**Re: CNM Pop-Up Pavillion**  
**101 Broadway Blvd. NE Albuquerque NM**  
**Traffic Circulation Layout**  
Engineer's/Architect's Stamp 08-01-2019 (K14D108A)

Based upon the information provided in your submittal received 08-14-2019, the above referenced plan cannot be approved for Building Permit until the following comments are addressed:

1 TCL Plan  
AS1.6 SCALE: 1" = 20 ft

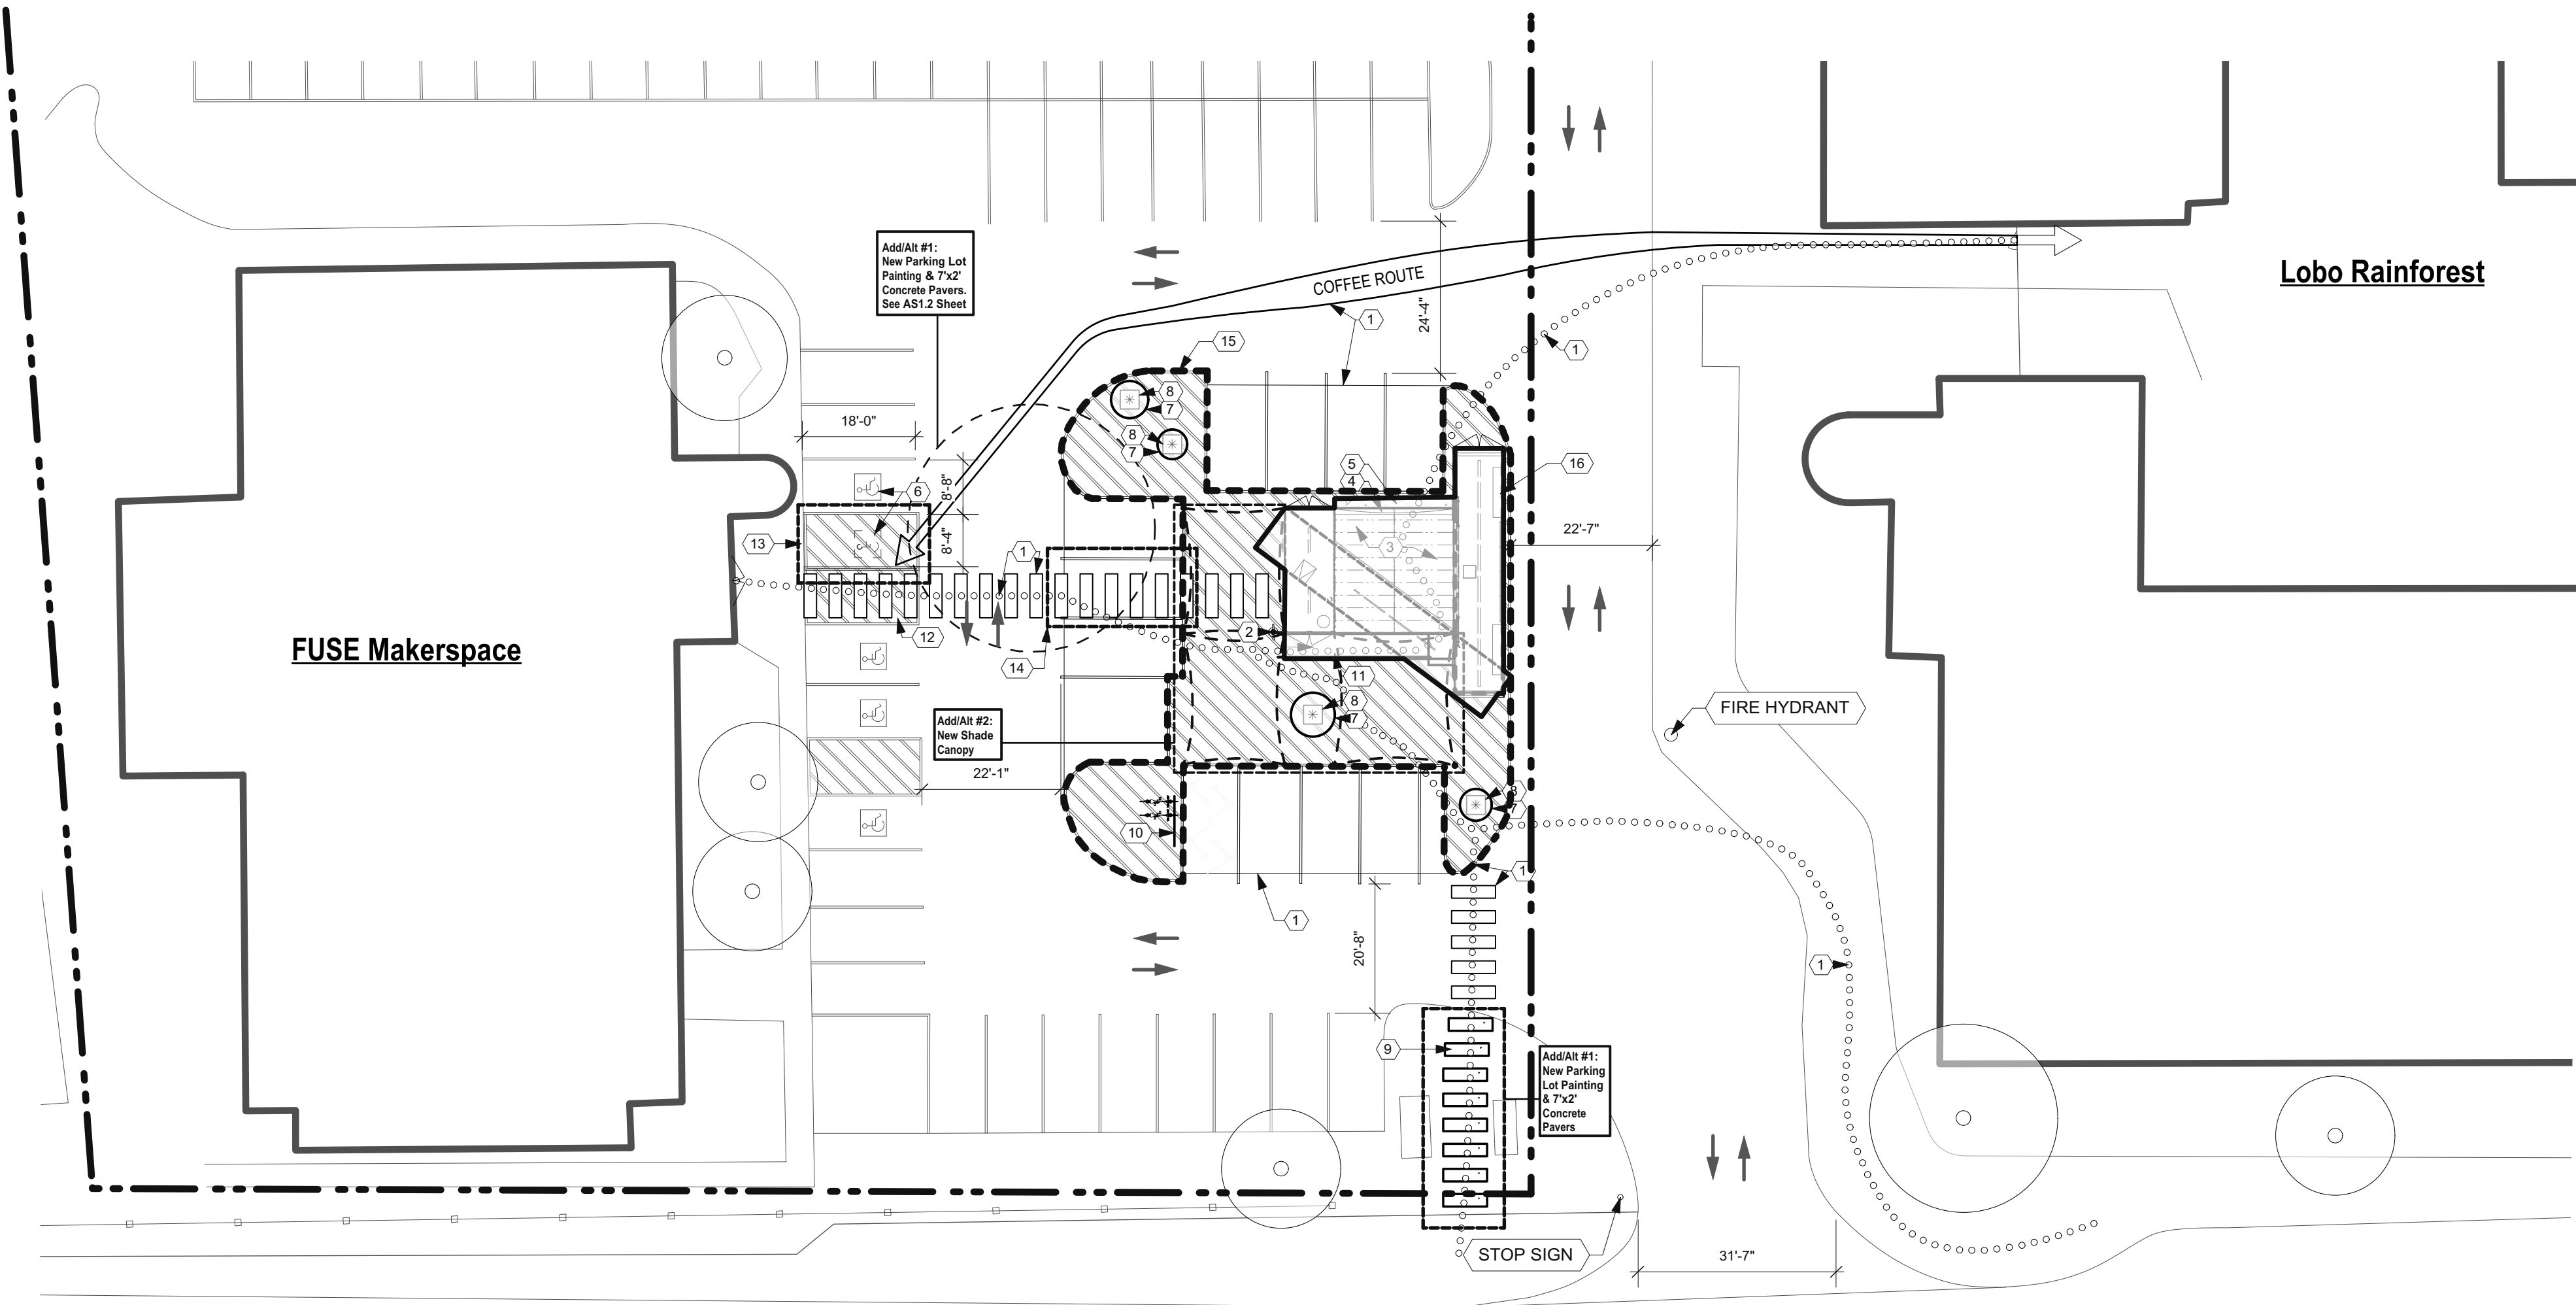
1. List the number of parking spaces required by the zoning code as well as the proposed number of parking spaces including bicycle and motorcycle parking.
2. Please list the width and length for all existing and proposed parking spaces. Some dimensions are not shown.
3. The minimum parking stall dimensions are:

4. Please show the property line.
5. The ADA accessible spaces must include an access aisle. Van accessible aisles should be 8ft wide; all others should be 5ft wide.
6. The ADA accessible parking sign must have the required language per 66-7-352.4C NMSA 1978 **"Violators Are Subject to a Fine and/or Towing."** Please call out detail and location of signs.
7. The ADA access aisles shall have the words **"NO PARKING"** in capital letters, each of which shall be at least one foot high and at least two inches wide, placed at the rear of the parking space so as to be close to where an adjacent vehicle's rear tire would be placed. (66-1-4.1.B NMSA 1978)
8. All bicycle racks shall be designed according to the following guidelines:

- a. The rack shall be a minimum 30 inches tall and 18 inches wide.
  - b. The bicycle frame shall be supported horizontally at two or more places. Comb/toaster racks are not allowed.
  - c. The rack shall be designed to support the bicycle in an upright position. See the IDO for additional information.
  - d. The rack allows varying bicycle frame sizes and styles to be attached.
  - e. The user is not required to lift the bicycle onto the bicycle rack.
  - f. Each bicycle parking space is accessible without moving another bicycle.
- 9. Bicycle racks shall be sturdy and anchored to a concrete pad.
  - 10. A 1-foot clear zone around the bicycle parking stall shall be provided.
  - 11. Bicycle parking spaces shall be at least 6 feet long and 2 feet wide.
  - 12. The minimum drive aisle dimensions are shown below

- 13. List radii for all curves shown; for passenger vehicles. Radius for delivery trucks, fire trucks, etc. is 25 ft. or larger.
- 14. Per the IDO, a 6 ft. wide ADA accessible pedestrian pathway is required from the public sidewalk to the building entrances. Please clearly show this pathway and provide details.
- 15. Per DPM, a 6 ft. wide ADA accessible pedestrian pathway is required from the ADA parking stall access aisles to the building entrances. Please clearly show this pathway and provide details.
- 16. Refuse vehicle maneuvering shall be contained on-site. The refuse vehicle shall Once corrections are complete resubmit
- 17. Provide a shared cross access agreement.
  - 1. The Traffic Circulation Layout
  - 2. A Drainage Transportation Information Sheet (DTIS)
  - 3. Send an electronic copy of your submittal to PLNDRS@cabq.gov.
  - 4. The \$75 re-submittal fee.
